Proposed waste disposal site at Narngulu

Shire of Greenough and City of Geraldton

**Report and recommendations of the
Environmental Protection Authority**

**Environmental Protection Authority
Bulletin 505
March 1991**

Figure 1: Waste facilities concept plan for Meru

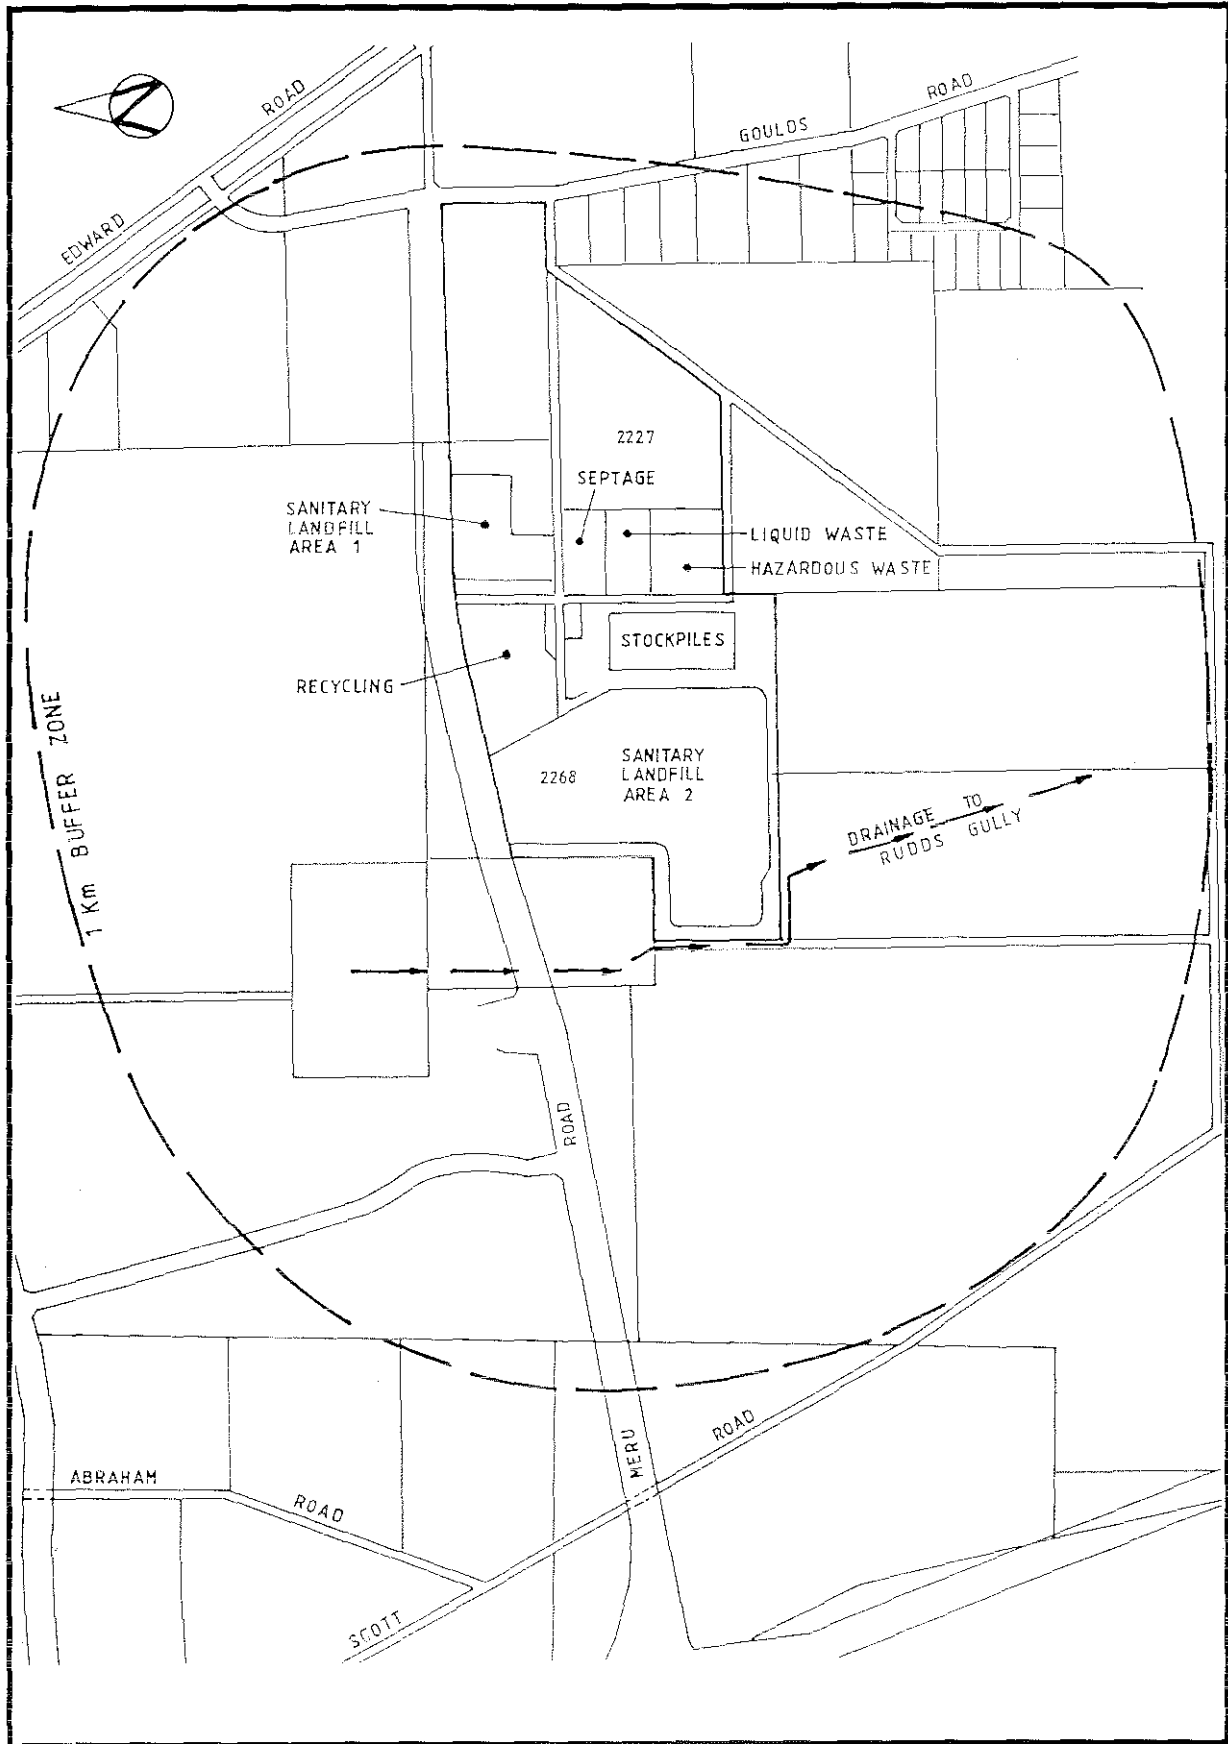
Approval is sought for the construction and operation of a solid (domestic) waste landfill site and for the concept of locating various types of waste disposal facilities, such as septage ponds, at the same site (See Figure 1). The waste facilities concept plan shows sites for both liquid and hazardous waste treatment which would be constructed at a later date when there is a demand for this type of waste disposal. Liquid and hazardous waste would not be accepted until appropriate approvals have been sought and obtained.

A 1000 m buffer zone, as shown in Figure 1, would be enforced around the site in which no new residential developments would be allowed to ensure both long term operation of the landfill and minimum inconvenience to future residents near the landfill.

The Shire of Greenough has made a commitment to putting in place a buffer zone around the Meru facility in which all new residential developments would be excluded until the end of the working life of the facility and has stated that the buffer zone will be to the satisfaction of the Environmental Protection Authority. The proponents have proposed a minimum buffer zone of 1000 m (See Figure 1 of this report).

The Victorian Environment Protection Authority recommends minimum buffer zones of 200 m and 500 m in urban and non-urban zones respectively for putrescible landfill sites, however given that other waste facilities such as septage ponds are likely to be proposed in the future, the 1000 m buffer zone proposed is considered appropriate.
